APPLICATION NO.	FILING DATE	FIRST NAMED INVENTOR	ATTORNEY DOCKET NO.	CONFIRMATION NO.
10/600,698	06/23/2003	Masakazu Okuda	053588-5012	5737
9629	7590	09/15/2004	EXAMINER	
MORGAN LEWIS & BOCKIUS LLP 1111 PENNSYLVANIA AVENUE NW WASHINGTON, DC 20004			MOUTTET, BLAISE L	
			ART UNIT	PAPER NUMBER
			2853	
DATE MAILED: 09/15/2004

Office Action Summary	Application No. 10/600,698	Applicant(s) OKUDA ET AL. AK	
	Examiner Blaise L Mouttet	Art Unit 2853

DETAILED ACTION

**FIG. 3**

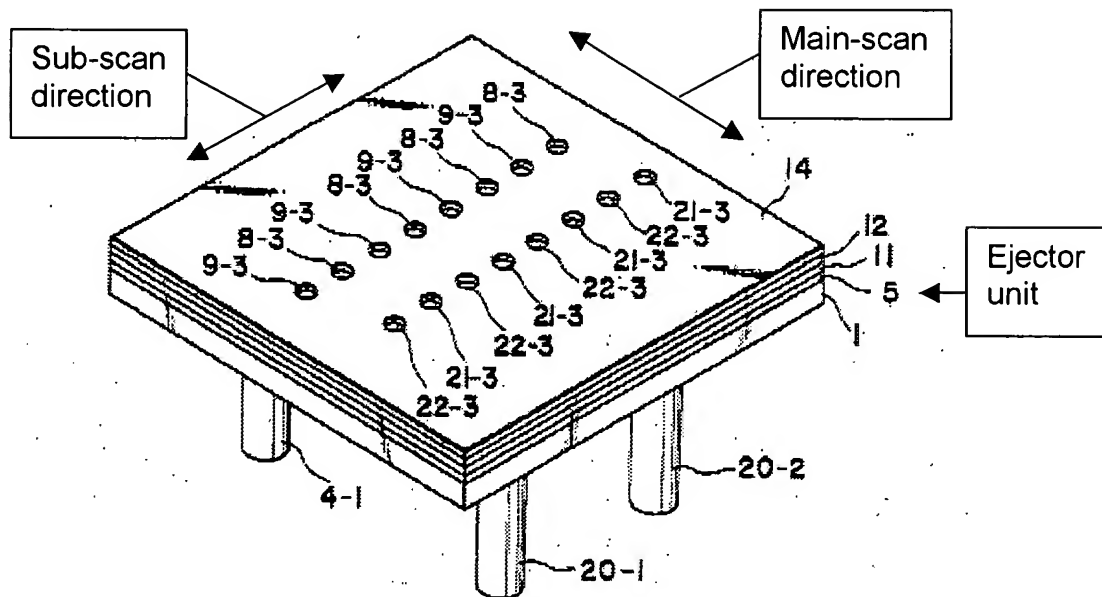
Sugitani et al. discloses, regarding claim 1, a liquid drop discharging head (figure 3) comprising one ejector unit arranged along a main scanning direction (as shown on the following page), wherein:

the ejector unit includes a first ejector group (the ejectors corresponding to nozzles 21-3 and 22-3 in figure 3) arranged at one side in the main scanning direction and a second ejector group (the ejectors corresponding to nozzles 8-3 and 9-3) arranged at another side in the main scanning direction,

each ejector group includes a plurality of ejectors (2) (as explained in relation to column 2, lines 40-59, ejector elements 2 are provided corresponding to each nozzle to enable liquid ejection),

all of the ejectors are arranged two dimensionally in a predetermined plane (figure 3),

each ejector includes a nozzle (the nozzles 8-3, 9-3, 21-3, 22-3 each correspond to an associated ejector 2);

all of the nozzles are offset from each other in a sub-scanning direction which is perpendicular to the main scan direction (as shown in figures 3, 7 and 8 the left column of nozzles is staggered relative to the right column of nozzles),

the nozzles of each ejector group are alternately arranged so that when they are viewed in the main scanning direction, a nozzle of one ejector of the first ejector group, a nozzle of one ejector of the second ejector group, a nozzle of another ejector of the first ejector group, a nozzle of another ejector of the second ejector group, etc. are arranged in such an order in the sub-scanning direction (as shown in figure 3 nozzles are arranged in the sub-scan direction in the order 21-3, 8-3, 22-3, 9-3, etc.)

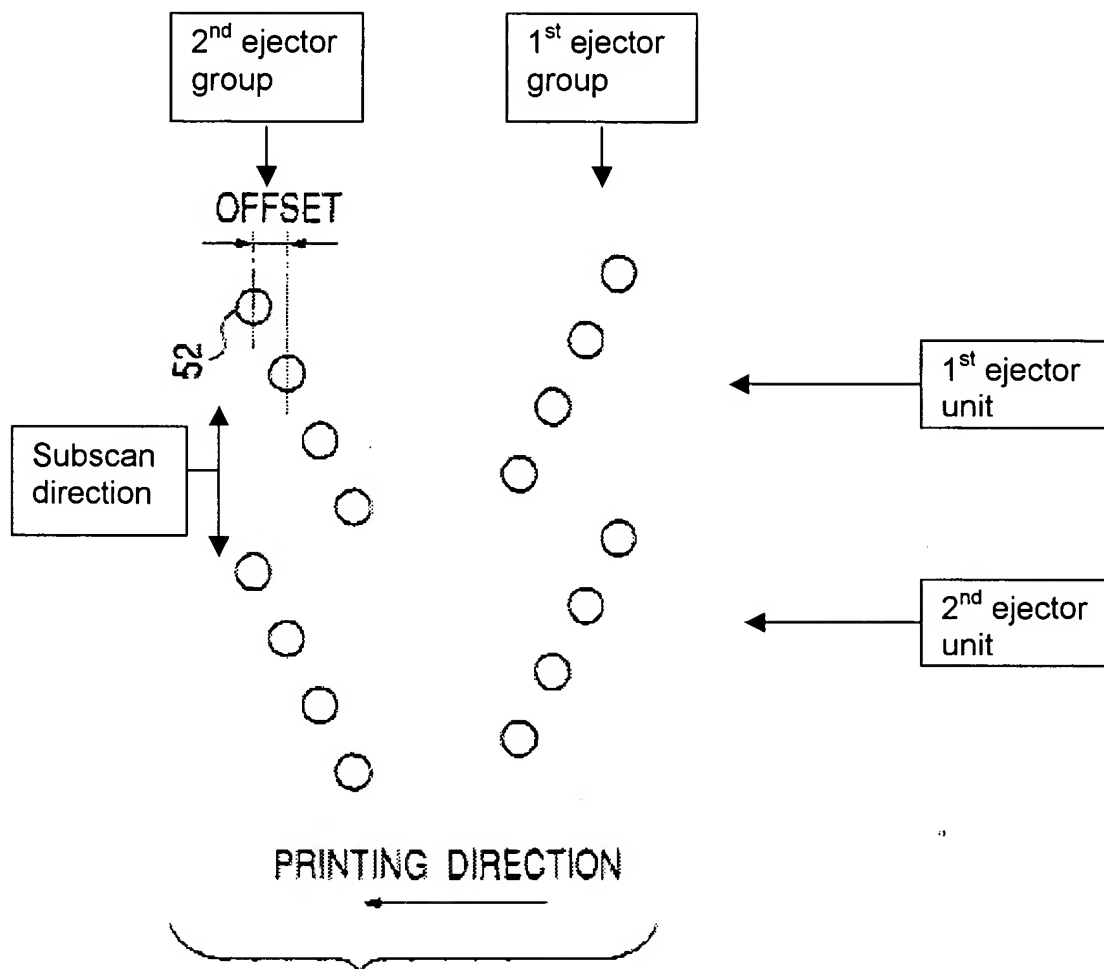
Tsuchii et al. discloses, regarding claim 1, a liquid drop discharging head (figures 1A-1C) comprising ejector units arranged along a main scanning direction (printing direction of figures 1A and 1B), wherein:

each ejector unit includes a first ejector group (shown on the following page) arranged at one side in the main scanning direction and a second ejector group (shown on the following page) arranged at another side in the main scanning direction,

each ejector group includes a plurality of ejectors (51) (page 25, lines 25-30),
all of the ejectors are arranged two dimensionally in a predetermined plane (figure 1B),

each ejector includes a nozzle (52) (page 25, lines 31-36);

all of the nozzles are offset from each other in a sub-scanning direction which is perpendicular to the main scan direction (as evident from figures 1A and 1B),

the nozzles of each ejector group are alternately arranged so that when they are viewed in the main scanning direction, a nozzle of one ejector of the first ejector group,

a nozzle of one ejector of the second ejector group, a nozzle of another ejector of the first ejector group, a nozzle of another ejector of the second ejector group, etc. are arranged in such an order in the sub-scanning direction (as shown in figure 1B nozzles are arranged in the sub-scan direction such that the uppermost nozzle of the 1st group (right side group) is arranged, followed by the uppermost nozzle of the 2nd group (left side group), followed by the second uppermost nozzle of the 1st group, followed by the second uppermost nozzle the 2nd group, etc.)

Regarding claim 9, all of the ejectors in each ejector unit together form a V-shape (figure 1B).

FIG. 2

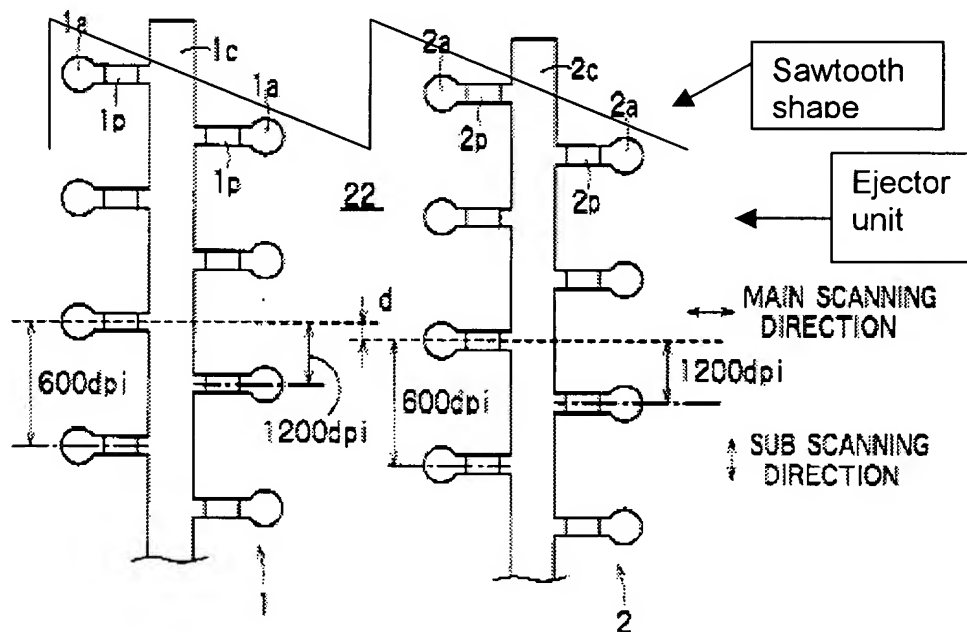
Chang discloses, regarding claim 1, a liquid drop discharging head (22) comprising an ejector unit arranged along a main scanning direction (figure 2), wherein:

the ejector unit includes a first ejector group (1) arranged at one side in the main scanning direction and a second ejector group (2) arranged at another side in the main scanning direction (figure 2, column 6, lines 17-23),

all of the ejectors are arranged two dimensionally in a predetermined plane (figure 2),

all of the nozzles are offset from each other in a sub-scanning direction which is perpendicular to the main scan direction (as shown in figure 2 and described in column 8, lines 41-49),

the nozzles of each ejector group are alternately arranged so that when they are viewed in the main scanning direction, a nozzle of one ejector of the first ejector group, a nozzle of one ejector of the second ejector group, a nozzle of another ejector of the first ejector group, a nozzle of another ejector of the second ejector group, etc. are arranged in such an order in the sub-scanning direction (as shown in figure 2 nozzles are arranged in the sub-scan direction such that the uppermost left nozzle of group 1a is arranged, followed by the uppermost left nozzle of group 2a, followed by the uppermost right nozzle of group 1a, followed by the uppermost right nozzle of group 2a, etc.)

Regarding claim 8, all of the ejectors in each ejector unit together form a sawtooth shape when viewed in a plan view as indicated on the following page.
